Engineering/Process Change Notice

ECN/PCN No.: 3872

For Manufacturer							
Product Description: 32.768kHz SMD Low Profile Crystal	Abracon Part Number / Part Series: ABS05		□ Documentation only⋈ ECN□ EOL	⊠ Series □ Part Number □			
Affected Revision:	New Revision:		Application:	☐ Safety☒ Non-Safety			
	F	Recommended la	Application:

Alternative Mechanical Dimensions #1

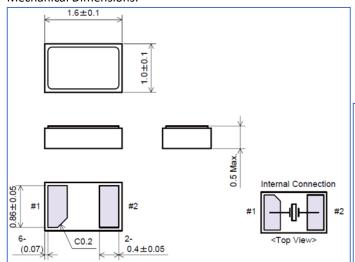
Abracon introduced additional manufacturing sources to ensure product availability and to be in a better position to meet long term customer demand. Additional package dimensions included to reflect the product produced by all manufacturing sources.

- Mechanical Dimensions and Tolerances:
 - The package mechanical dimension revisions do not impact the electrical performance of the device.
- PCB Landing Pattern:
 - There is no impact on the PCB layout/landing pattern for customer's existing boards.
